Item Name: Crosstube Turning Detail

DART AEROSPACE LTD	Work Order:	96765
Description: Crosstube Assembly	Part Number:	D206-667-243
Inspection Dwg: D206-667-243 Rev: C		Page 1 of 2

DRAWING NO. D206-667-243	TITLE CROSSTUBE ASS'Y (206L HIGH AFT)	REV. C	DART AEROSPACE LTD ENGINEERING ORDER		D.E.O. NO. D206-667-243-C-1	SHEET NO. SHEET 1 OF 1	SCALE NTS
DRAWN AP	CHECKED ASS	MFG. APPR. RB	APPROVED MP		DE APPR. #		
DATE 11.07.15	DATE 11.07.20	DATE 11.07.21	DATE 11/07/21		DATE 11.07.21

PURPOSE:

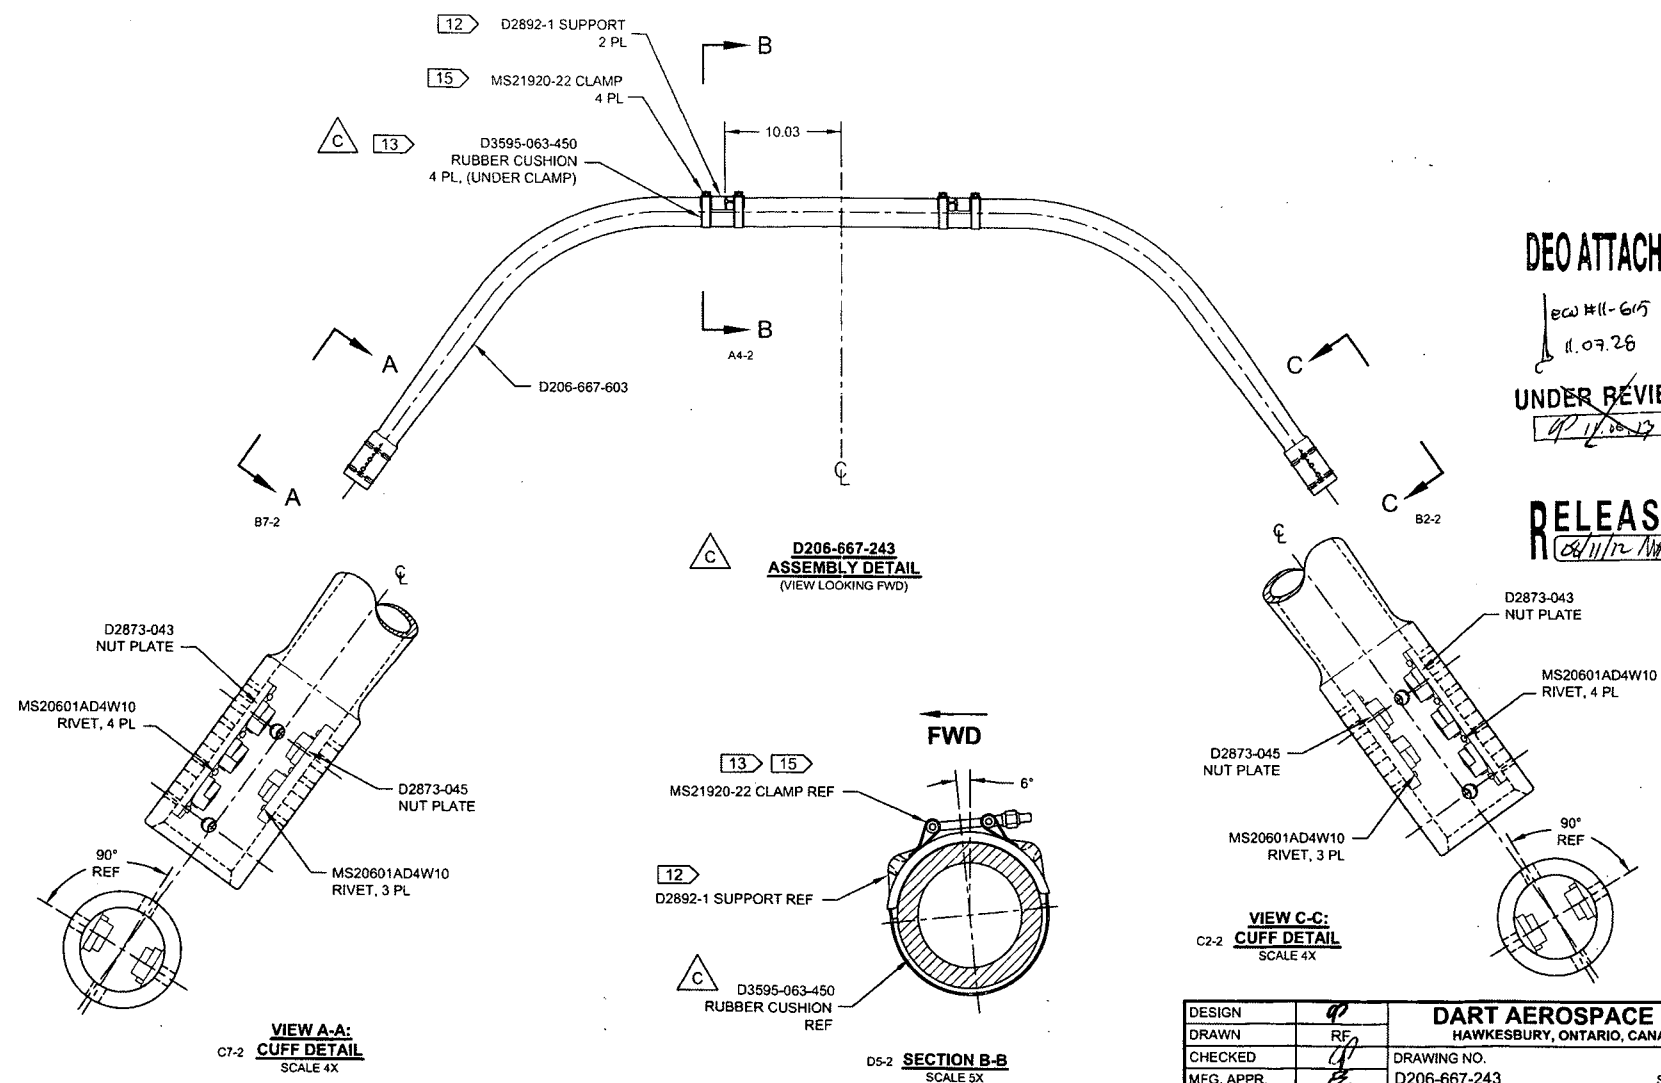
REPLACE MAGNOBOND WITH PROSEAL.

NOTE 12 & 15, SHEET 1 IS AMENDED AS FOLLOWS:

Item	Qty -243	Part Number	Description
9	A/R	PROSEAL 890 B-2	SEALANT, AMS-S-8802 CLASS B-2

- 12) TO INSTALL D2892-1 SUPPORT: ABRASE MATING SURFACE OF SUPPORT AND CROSSTUBE WITH 180-GRIT SANDPAPER AND REMOVE RESIDUE WITH MEK (OR EQUIVALENT). APPLY A 0.04" TO 0.07" THICK LAYER OF PROSEAL 890 CLASS B-2 (OR AMS-S-8802 CLASS B-2) SEALANT TO MATING SURFACE OF SUPPORT.
- 15) TORQUE CLAMPS 80 TO 100 IN-LB. ENSURE AT LEAST 1.5 THREADS SHOWING IN SAFETY AND THAT NUT HAS NOT BOTTOMED-OUT AFTER TORQUING. **PRIOR TO PACKAGING, RE-CHECK TORQUE ON CLAMPS AFTER PROSEAL 890 SEALANT HAS CURED FOR 72 HOURS.**
